## Ringwood Mines/Landfill Superfund Site Fact Sheet – February 2021

### Summary of Ringwood Mines/Landfill Superfund Site Operable Unit (OU) 2 Remedial Action Work Plan

This fact sheet covers the Ringwood Mines/Landfill Superfund Site OU2 Remedial Action Work Plan (RAWP), submitted to EPA in December 2020, available online at:

**Figure 2: Proposed Truck Access Routes to Each Area**

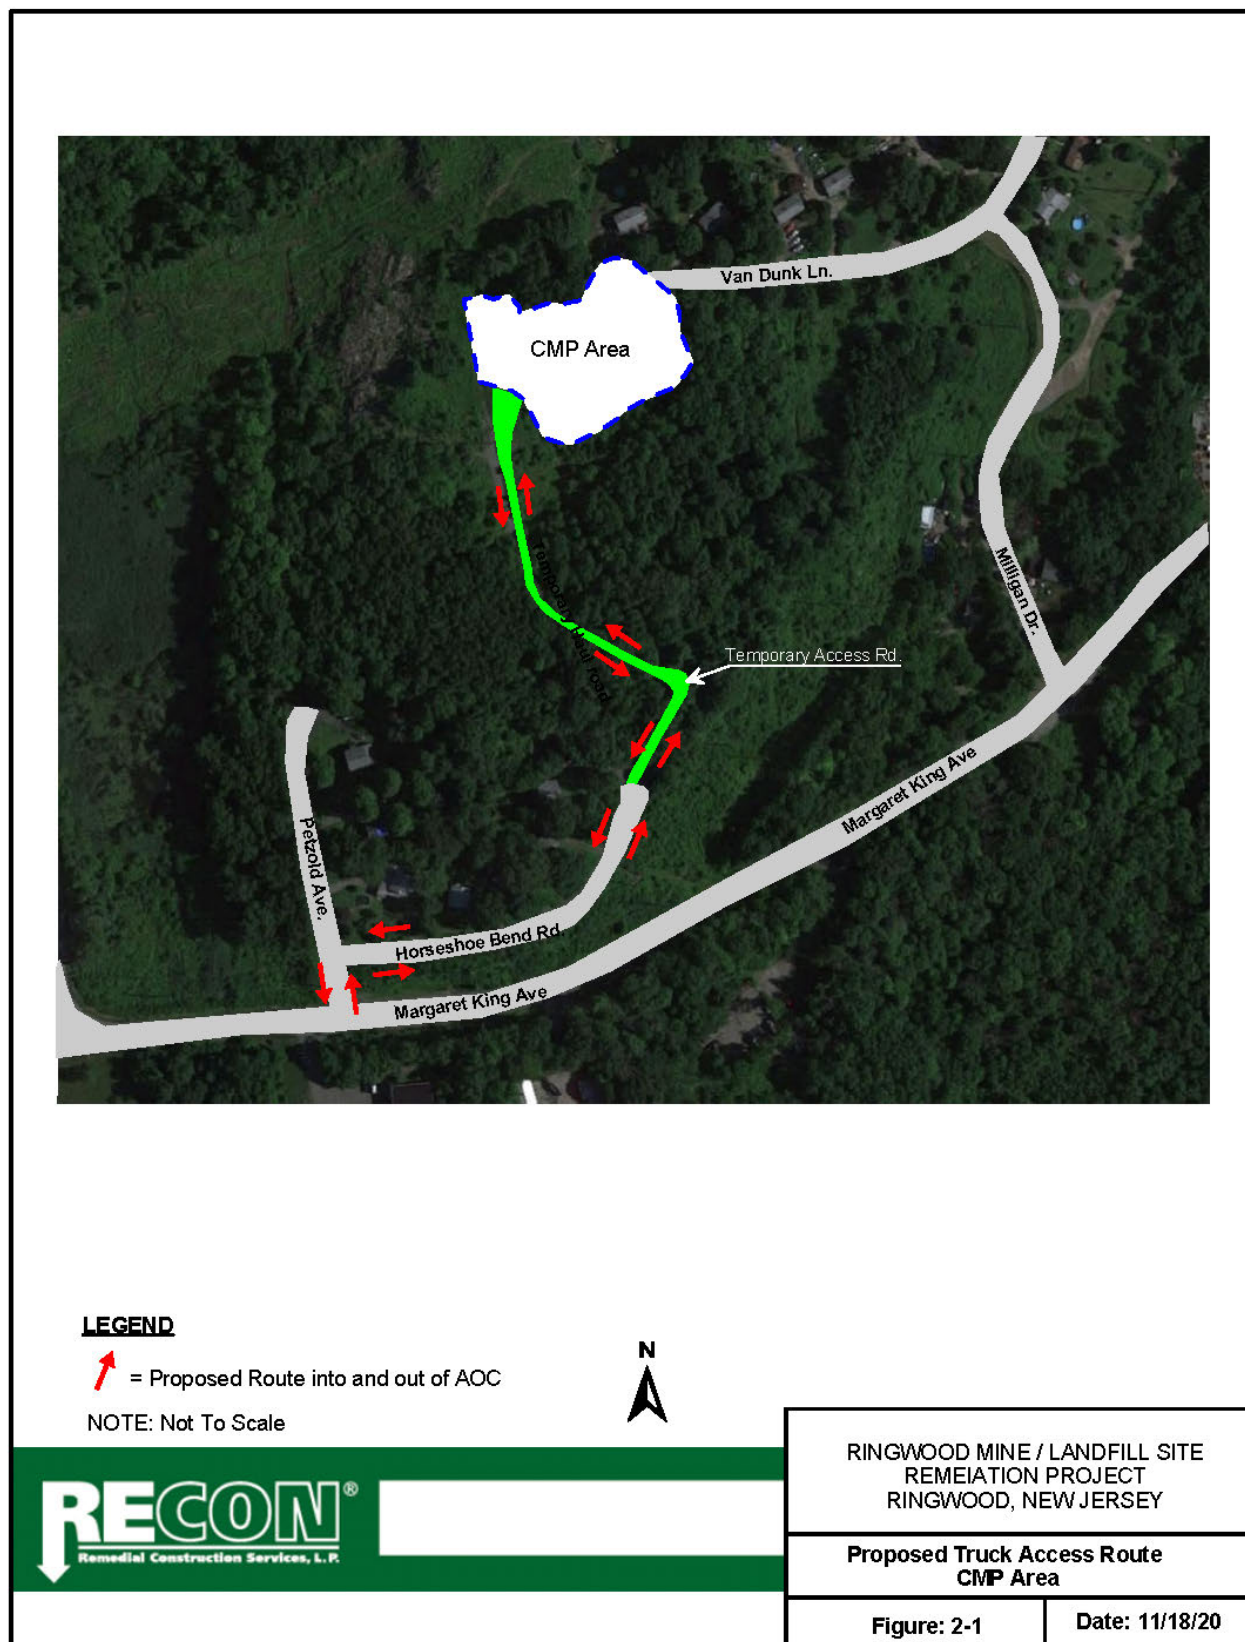
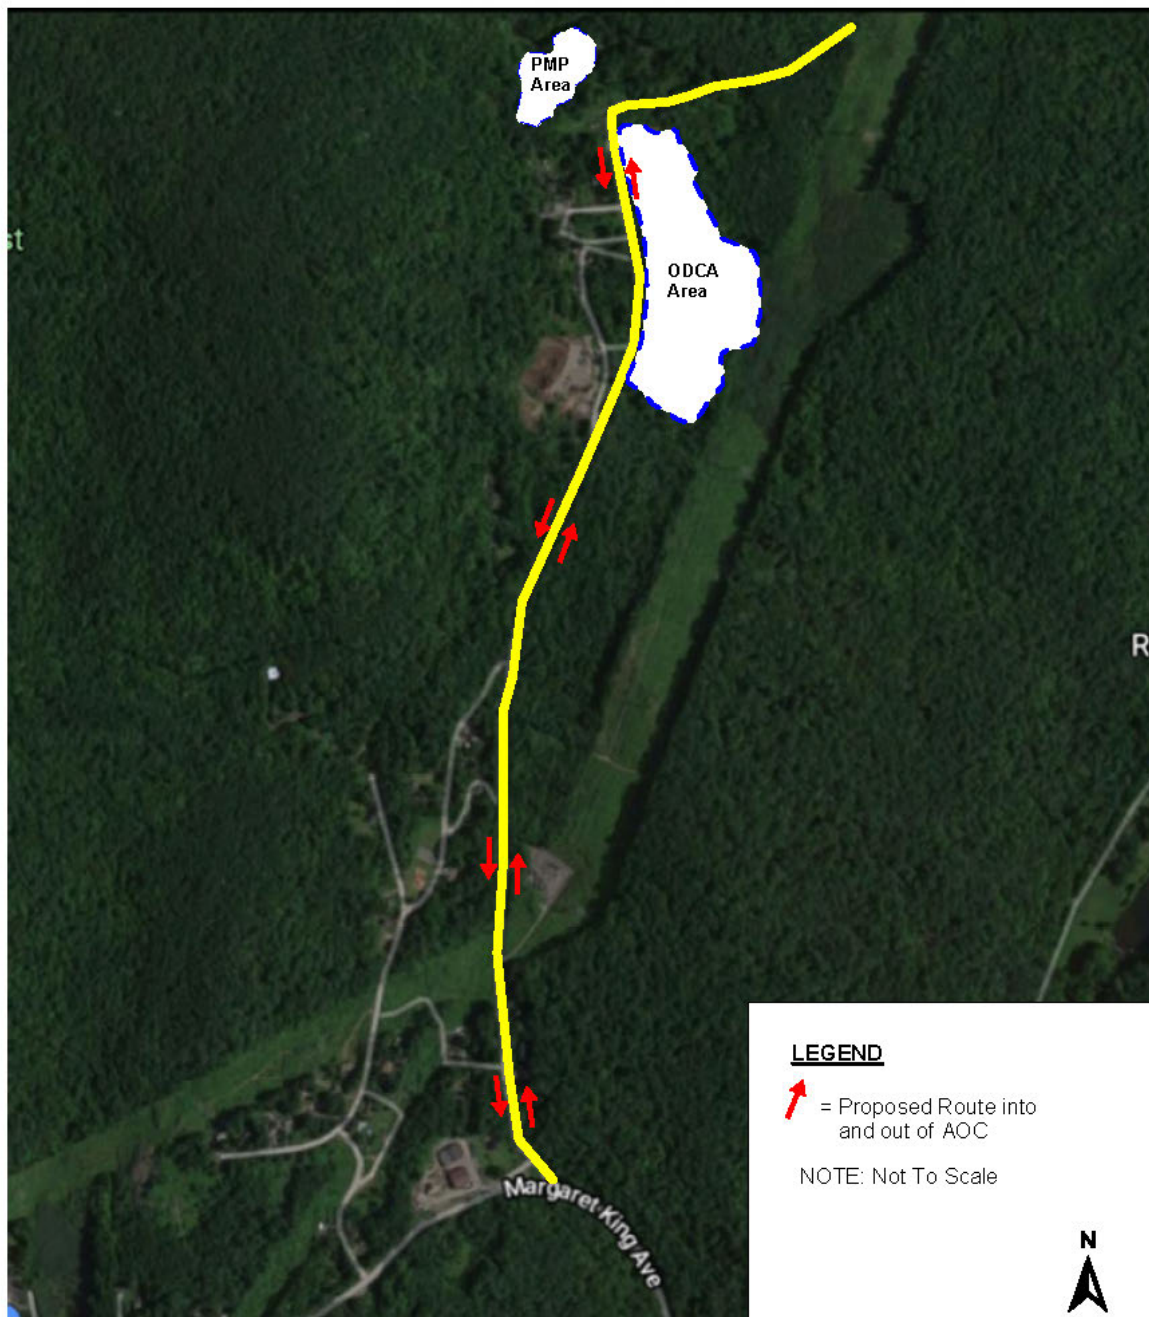
**Technical Comment #11:** Section 7.6 provides information about materials management. Coordination of disposal to approved facilities will occur between the contractor and Ford Motor Company. Figure 2 in this report shows proposed truck access routes. *If community members have preferences for when waste will be moved off site, such as avoiding times when school buses or children are outside, they may want to share that information with EPA.*

**Figure 3: Site Layout Plans**

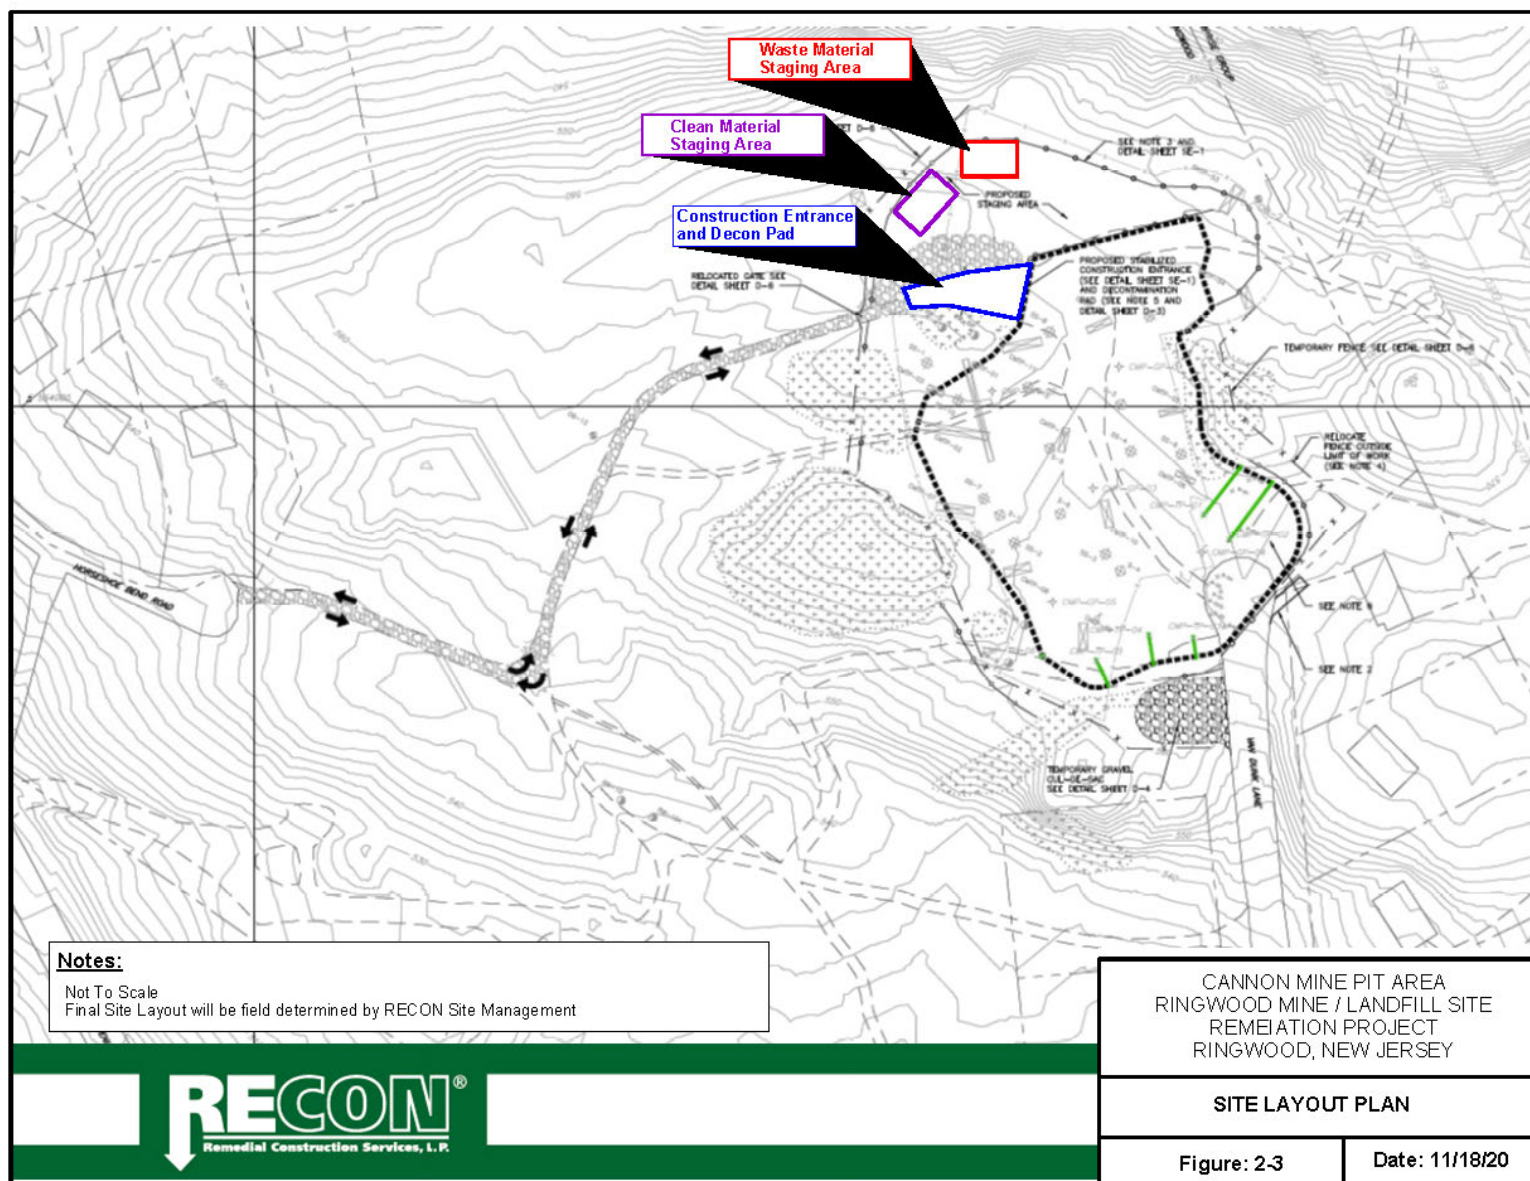
**Technical Comment #4:** Section 6 provides information on site mobilization and preparation. It includes subsections 6.2.1, 6.2.2, 6.2.3, 6.2.4 and 6.2.5. Each subsection addresses a specific area: the CMP Area, the OCDA and the PMP Area as well as new recycling center construction and current recycling center removal. *These sections may be of particular interest to the community. Community members may want to provide feedback on these sections to EPA.*

- Part of the work will take place in the Van Dunk Lane cul-de-sac. The driveway for the property owner to the north will be temporarily relocated (shown on Design Drawing CMP-2). Restoration of the resident's property driveway will follow, after completion of construction (Design Drawing CMP-3). *This resident may want to share any access-related concerns to their home during these activities with EPA.*

- The extended detention basin is sized using a 25-year storm scenario. *Community members may want to ask how this determination was made and whether a 100-year storm scenario could be applied.*

Figure 4: Sample Air Monitoring Locations (RAWP Attachment B)

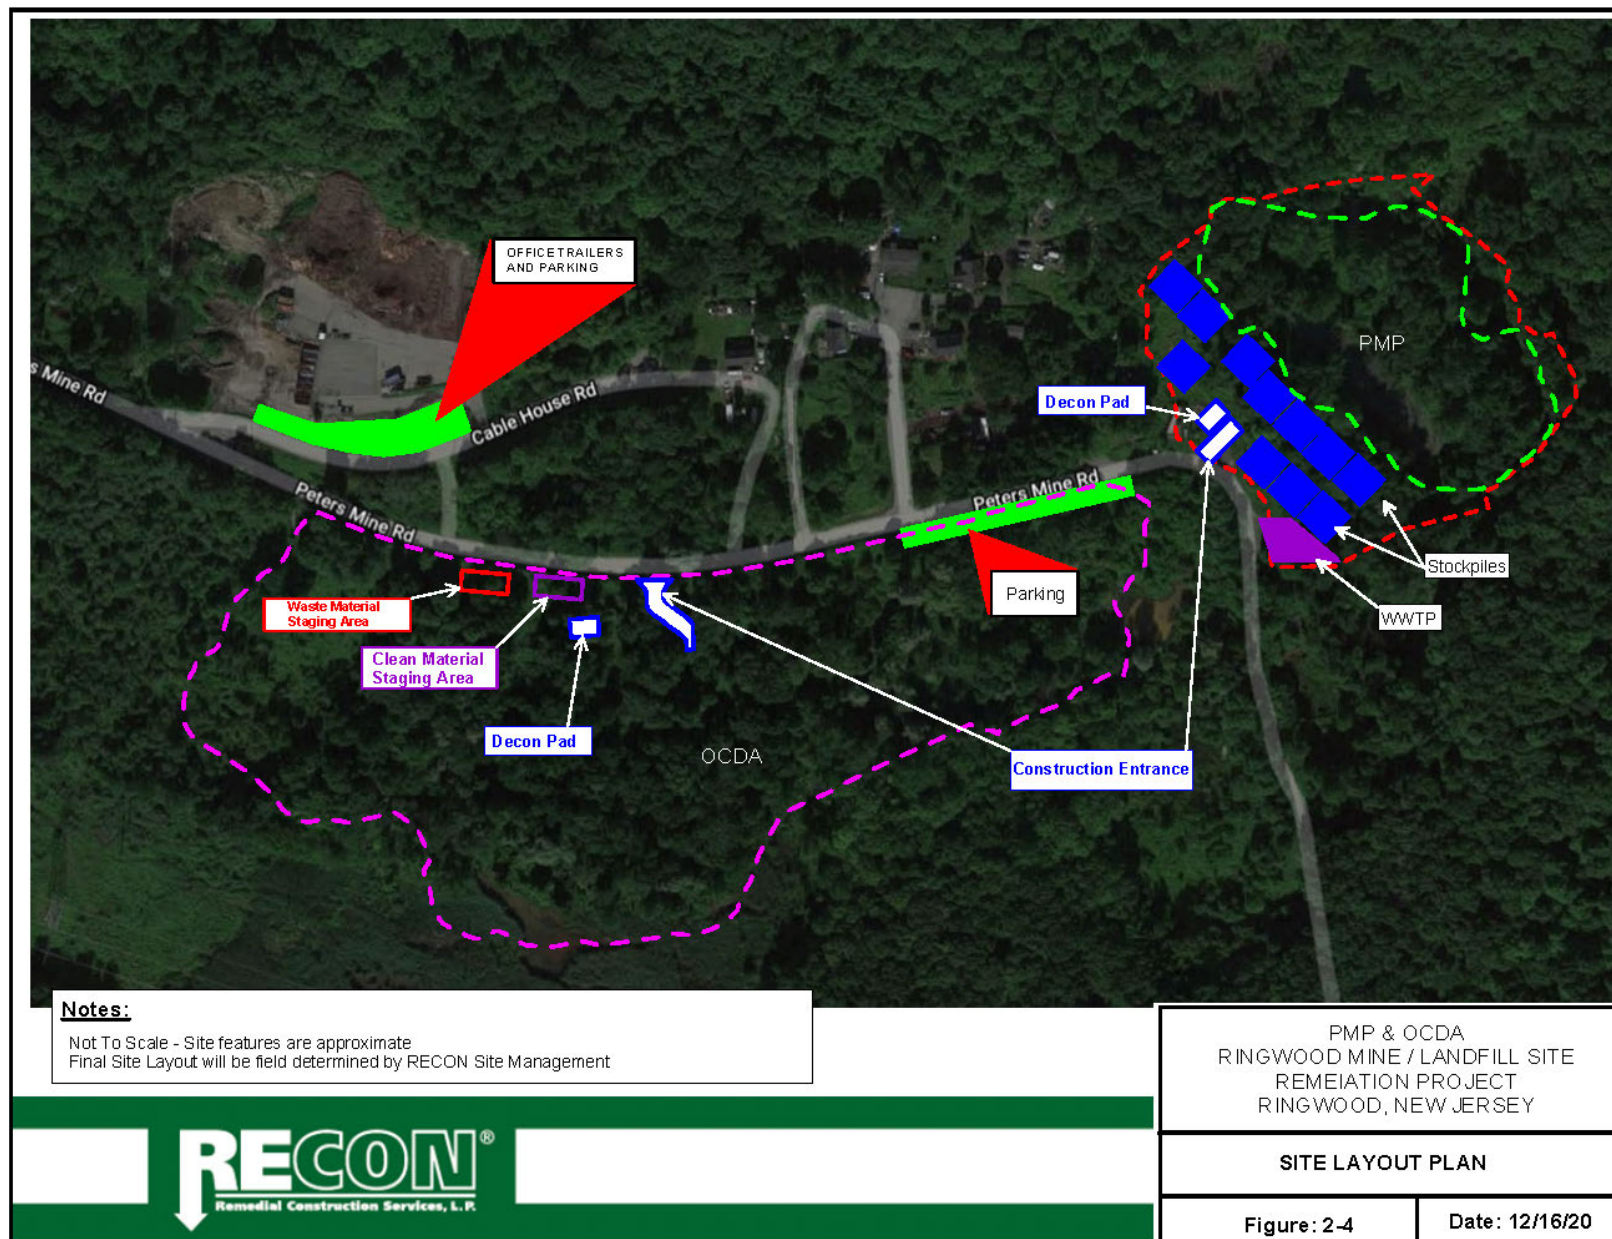
**Technical Comment #24:** Appendix D includes the CAMP. There will be three perimeter air monitoring stations in each active work area. Stations will be set up around the work area, with one upwind and two near the perimeter at downward locations. Actual monitoring station arrangement will be reviewed and modified

daily, based on the location of work and wind direction. *Community members may want to review the sample air monitoring station location maps (shown in Figure 4 at the end of this fact sheet) to make sure they are comfortable with this arrangement. They may also want to request communications about the actual placement locations of the stations during cleanup activities, including the distance the air monitors are located from the actual work. If community members know of sensitive populations or locations that should be monitored more closely, this information could help inform monitor placement.*
